Access Compliance Report Public Rights-of-Way (Curb Ramps)

Main Street: TIGERTAIL_DR		Cross Street: CHRISTY_LN		Location:	NW
ADA ID: RPRK211207131215	Ramp Type: Type 4 - Parallel	Initial Pass/Fail: Fail	Overall Compliance: No	Severity Score:	30
Codes/Mitigation Info/Possible Solution			Field Measurements/Component Compliance

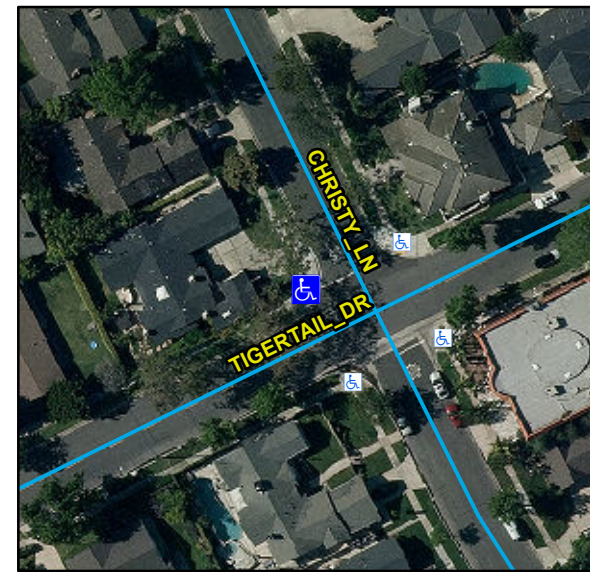
Compliance	Description	Data	Compliance	Description	Data
N/A	Ramp Length LT (in)	70	N/A	Ramp Length RT (in)	76
Yes	Ramp Width LT (in)	135	Yes	Ramp Width RT (in)	135
Yes	Ramp Run Slope LT (%)	5.2	Yes	Ramp Run Slope RT (%)	2
No	Ramp Cross Slope LT (%)	4.8	No	Ramp Cross Slope RT (%)	7.1
N/A	Landing Present	N/A	N/A	DWS Provided	N/A
N/A	Landing Length (in)	N/A	N/A	DWS Contrast	N/A
N/A	Landing Width (in)	N/A	N/A	DWS Length (in)	N/A
N/A	Landing Run Slope (%)	N/A	N/A	DWS Full Width	N/A
N/A	Landing Cross Slope (%)	N/A		DWS Offset Type	N/A
N/A	Landing Movement Obstructed?	N/A	N/A	DWS Offset Left (in)	N/A
	Landing Movement Type	N/A	N/A	DWS Offset Right (in)	N/A
N/A	Landing Shared	N/A			
N/A	Clear Space	Yes			
N/A	Clear Space To Crosswalk (in)	N/A			
N/A	Marked Crosswalk 1	No	N/A	Marked Crosswalk 2	No
	Crossing 1 Direction	S		Crossing 2 Direction	E
	Marked Crosswalk 1 Width (in)	N/A		Marked Crosswalk 2 Width (in)	N/A
N/A	Ramp Inside Crosswalk 1	N/A	N/A	Ramp Inside Crosswalk 2	N/A

Remove & Replace Curb Ramp With Two New Directional Ramps or Equivalent.
